**To:** Kathryn Espinoza, McKim & Creed  
**From:** Brian Chambers, Senior Planner; 910.342.2782  
**CC:** File;  
**Date:** 2/1/2021  
**Re:** Riverlights MX3 Road Improvements TRC Rev. 2

Project Name: Riverlights Mixed Use – Phase III Road Improvements

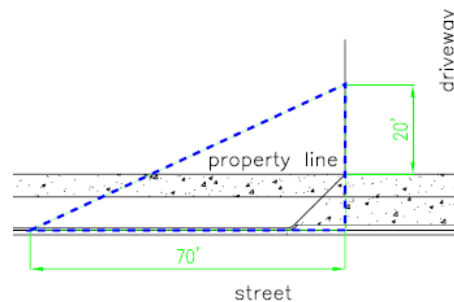
2. The City's 20'x70' and 46'x46' sight distance triangles are not applied and labelled in accordance with City standards. Please refer to the below image [Sec.18-529(c) (3) CofW LDC] [Sec. 18-812 CofW LDC].

- a. At the driveways, 20' shall be measured from the property line along the curb line.
  - b. City's 20' x 70' sight distance triangle is not required at the street intersections.

- c. 46'x46' is missing at the SW corner of Ledbury Rd and Quigley Blv.
  - d. The first east side access off Ledbury Rd is labelled as 20'x70' on sheet CS-102 whereas it is shown as 46'x46' and labelled as future street connection in sheet CS-100. Please reconcile the details.
